## ALERT SERVICE BULLETIN

# Replacement of the pressure side fuel hose at fuel pump part no. 893114 for ROTAX® Engine Type 912 (Series)

ATA System: 73-00-00 Fuel system

## Replacement of the pressure side fuel hose at fuel pump part no. 893114 for ROTAX® Engine Type 912 (Series)

Fig. 1  
Fuel pump

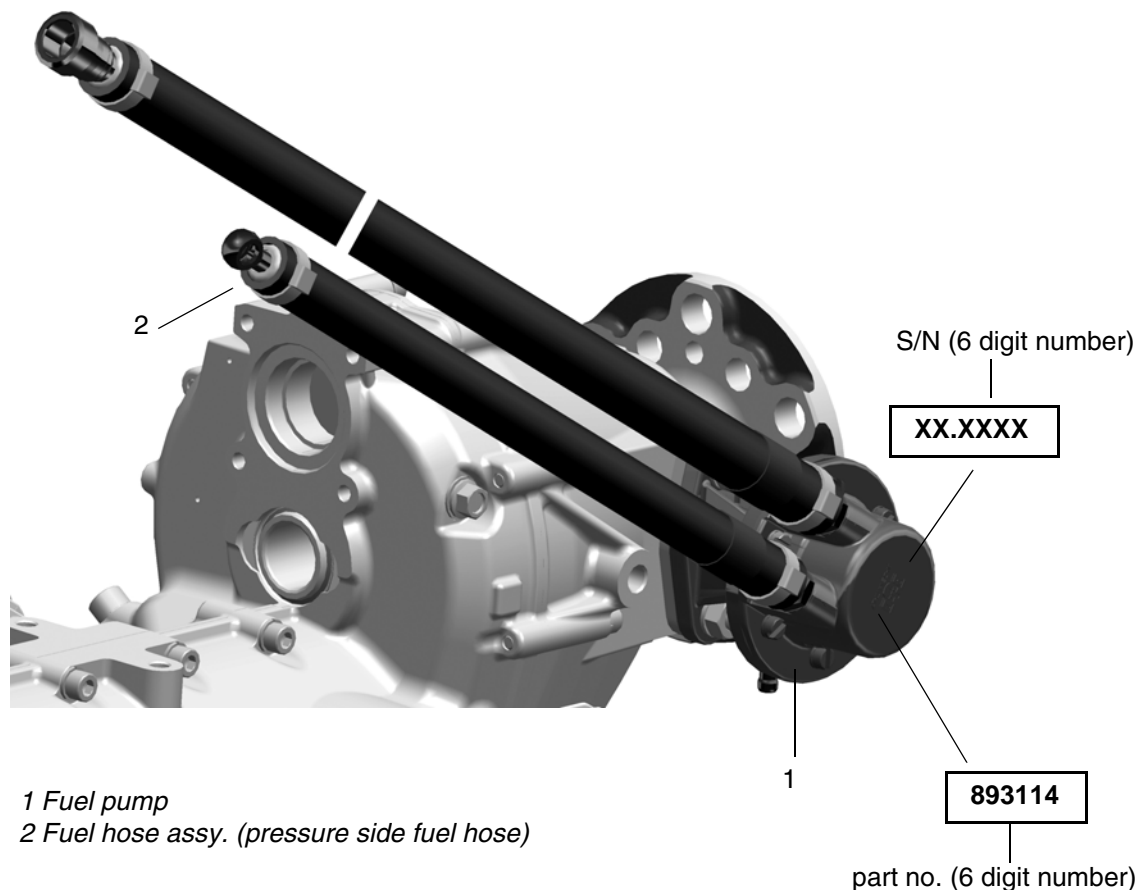
if they are equipped with the genuine ROTAX® fuel pump part no. 893114.

See [Fig. 1](#)

Due to variations in the manufacturing of the fuel hose, rubber particles may become detached. These particles can interfere or suppress the fuel mixture in the carburetor. This disturbance in the fuel mixture may lead to rough engine operation, engine misfire and can cause an engine shut down.

Replacement of the pressure side fuel hose at fuel pump part number 893114 for ROTAX® engine type 912 (Series).

- **Required before the next flight, the “replacement of the pressure side fuel hose“ identified by the engine or fuel pump serial number (S/N) listed in section 1.1) must be conducted according to the following instructions in section 3.**
